September 7, 1982
SBN-321
T.F. H 4.4.98
B 7.1.2

Subject: Seabrook Station Emergency Feedwater System Design Changes

SIMPLIFIED SKETCH OF THE
SEABROOK STATION
EFW SYSTEM

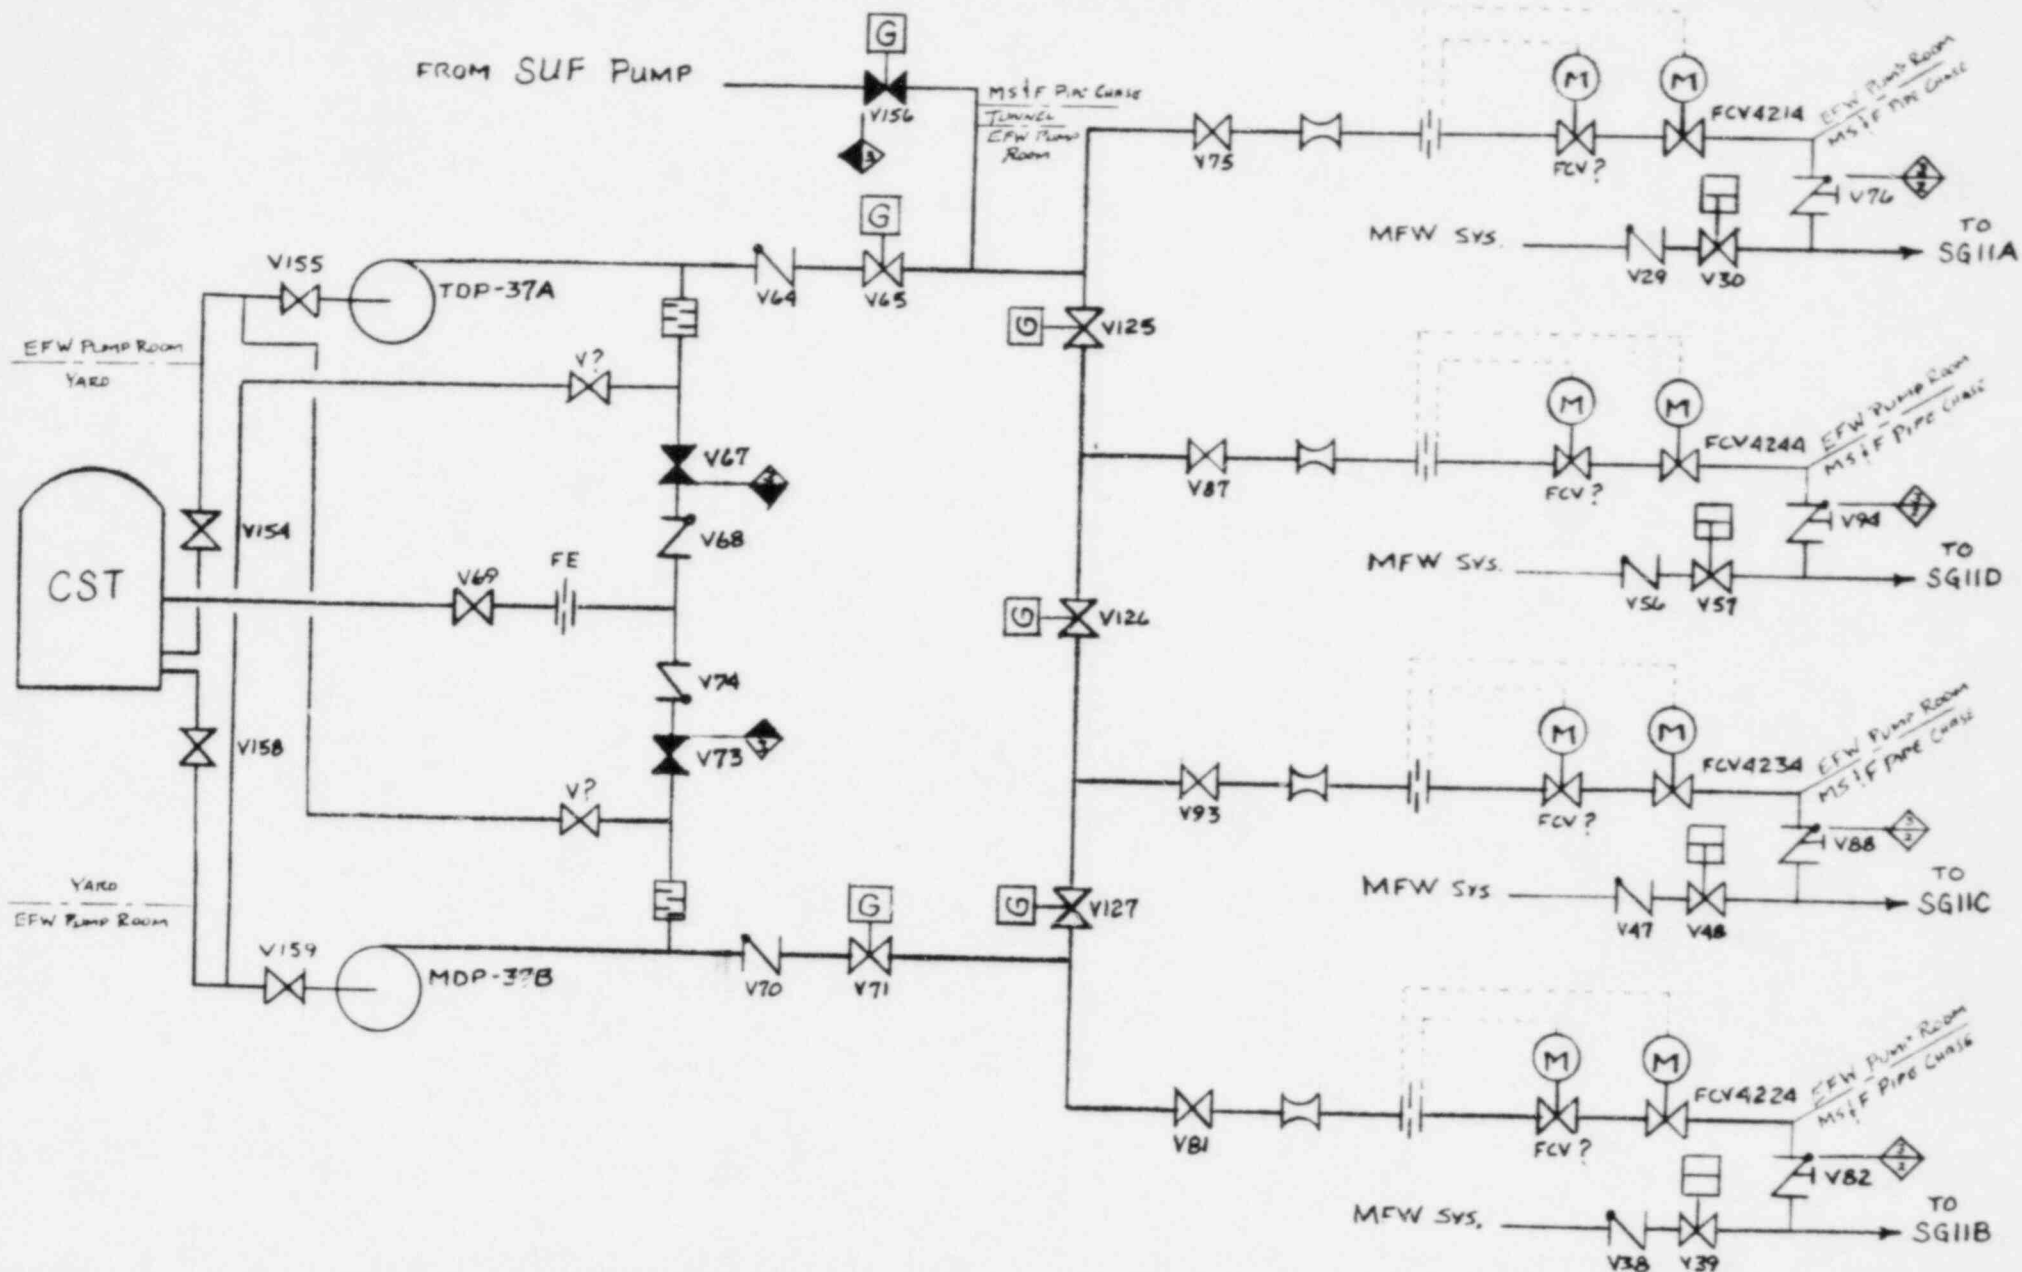
1. A continuous minimum flow recirculation path will be provided from each EFW pump's discharge to the condensate storage tank via the opposite pump's suction line. This recirculation path will assure a continuous flow through an EFW pump should flow to all four steam generators be reduced below that necessary to prevent pump damage. The original recirculation path will be retained for use during periodic pump performance testing.

2. Redundant, safety grade flow isolation valves will be provided in each EFW branch supply line to each steam generator. Safety grade controls will be provided at both the main control board and remote shutdown locations for these valves. Further information relative to this modification can be found in Reference (c).

3. Manual isolation valves will be provided upstream of each pair of flow isolation valves to each steam generator. These manual isolation valves will permit isolation of any EFW flow isolation valve while retaining the availability of both EFW pumps and the Startup Feedwater pump.

4. Safety grade, Seismic Category I air accumulators will be provided as a back-up air supply for the actuators of both main steam supply valves (MS-VI27 and MS-VI28) to the turbine-driven EFW pump, P-37A. These accumulators will be sized to provide at least two complete valve operations plus maintain the valves closed for a minimum of four hours. This safety grade air supply will upgrade the reliability of these valves consistent with the Class 1E controls presently utilized in the design.

5. The Startup Feedwater (SUF) pump discharge valve to the EFW header, FW-VI56, will be relocated out of the EFW Pump Room. This will assure the ability to cross-tie the SUF pump to the EFW System should use a series of potential failures render both EFW pumps inoperable and the EFW Pump Room inaccessible.
